PROJECT: THE WORLD TRADE CENTER | TITLE: REVISION AFTER FABRICATION - DETAIL 916 | DATE: 12-30-68

19-B-916

PLAN: PLAZA BEAM SEAT LOCATIONS

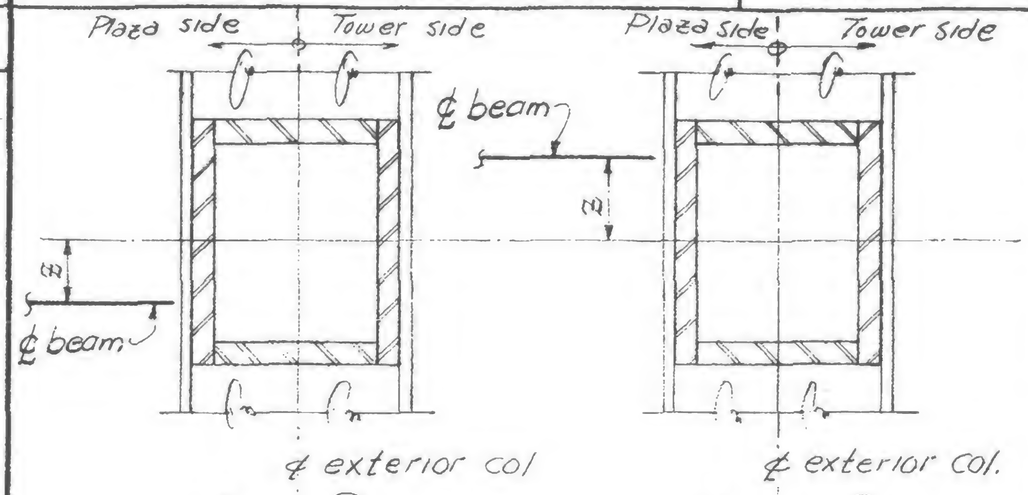
COLUMN LOCATION							
		224B	301B	312B	315B	351B	354B
Action Required		Note 1	Note 2	Note 2	Note 2	Note 1	Note 3
Previous Detail		P.I.N	P10B	P.I.A	P.I.A	None	None
New Seat Location	Type	①	②	①	②	on ℄	on ℄
	Z	0'-6"	0'-6"	2'-6"	1'-3"	0"	0"
Seat Design Data		—	Note 4	Note 4	Note 4	Note 5	Note 4
Plates	P	¾"				½"	
	Q	¾"				½"	
Dimensions	A	1'-2"				1'-0"	
	B	6"				6"	
	X	11"				11"	
	C	5½"				3½"	
Welds	1	⅜"				5/16	
	2	⅜"				5/16	
Beam Size		16WF58				16WF36	
Ref. Dwg: 1-AB3-60.1, -60.5

1. Provide new beam seat
2. Remove beam seat & web clip from loc. previously shown and install removed parts at new location shown.
3. Remove seat & clip previously scheduled for column 224B and install removed parts at col 354B
4. Seat details are the same as previously scheduled for this column. See reference dwg.
5. Seat detail is the same as previously scheduled under P.I.N.
6. Dress spandrel face after cutting off bm seats & web clips, by filling gouges with weld metal & for grinding burrs smooth.
7. New bm seats & clips may be installed in lieu of re-using exist'g parts, ℄ Contr's option.
